February 11, 2020 Planning Board Meeting

OFF HIGHLAND AVE/ABBY ROAD SUBDIVISION

TO: Winchester Planning Board
FROM: Beth Rudolph, PE, Town Engineer *BER*
DATE: February 6, 2020
RE: Abby Road Subdivision – Request for Release of Lots

Attachment 1

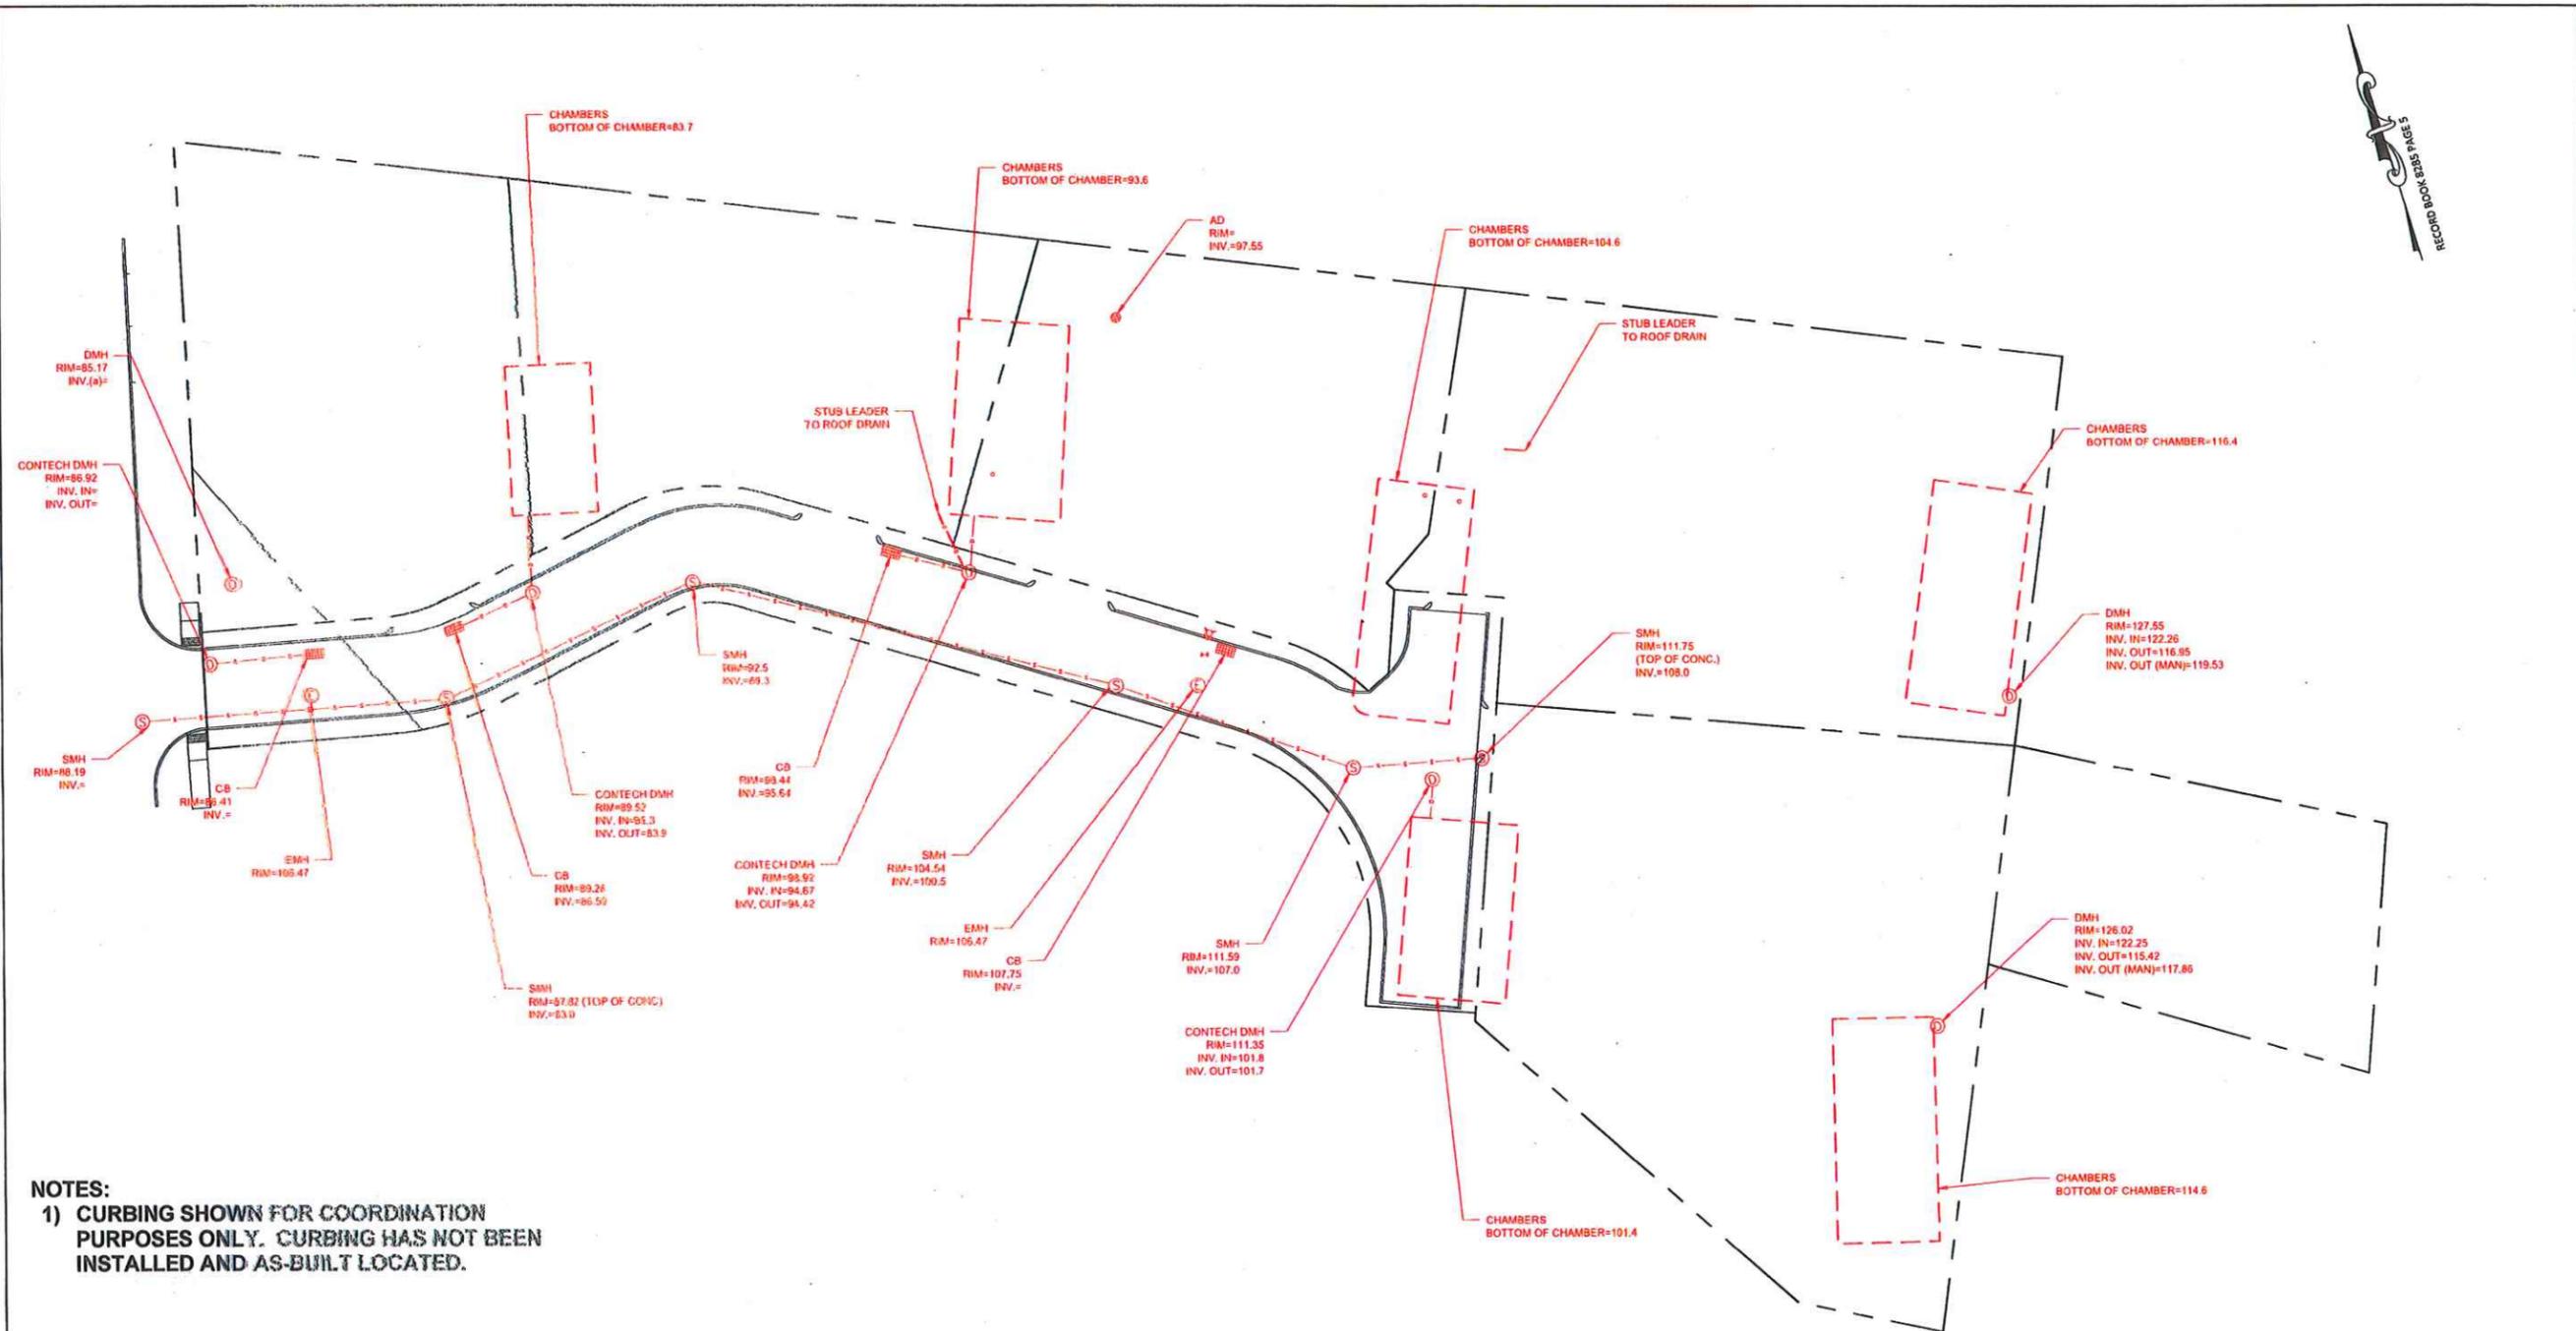
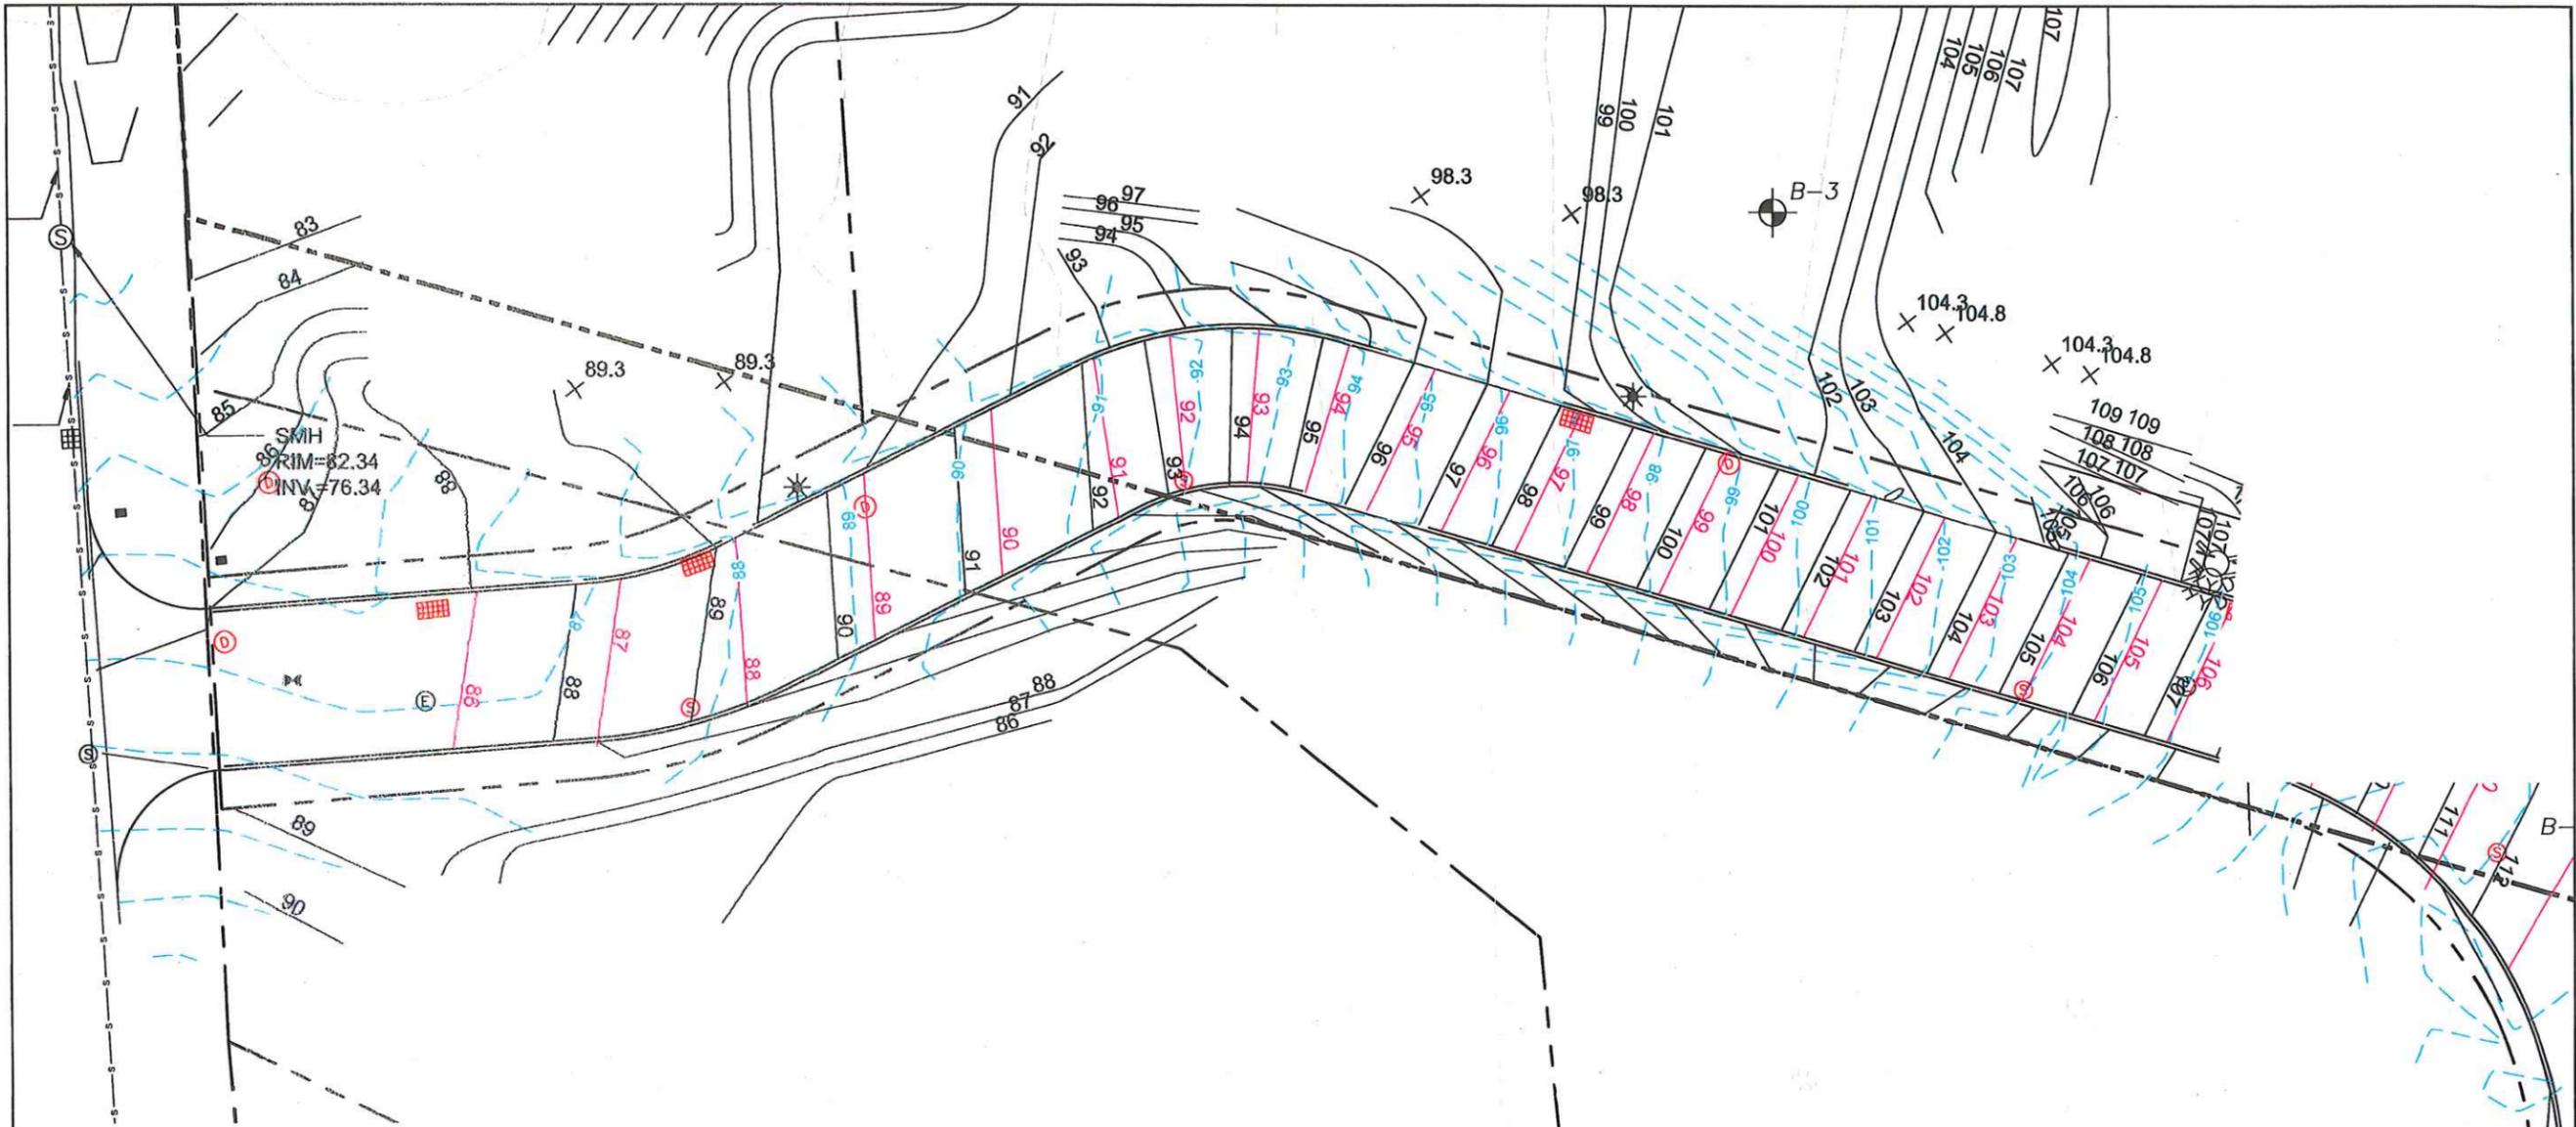
- (5) Interim As-built Plans – Prior to the release of the lots, the applicant should be required to provide an updated interim as-built plan for the project in accordance with the requirements of Section 7.21 of the Subdivision Regulations. The plans must be stamped by a Professional Land Surveyor and Professional Engineer, and include the certifications outlined in Section 7.21.2 of the Subdivision Regulations. Previous interim as-built plans were received on September 30 and November 11, 2019 (Attachment 1), but were not stamped nor did they include this certification.
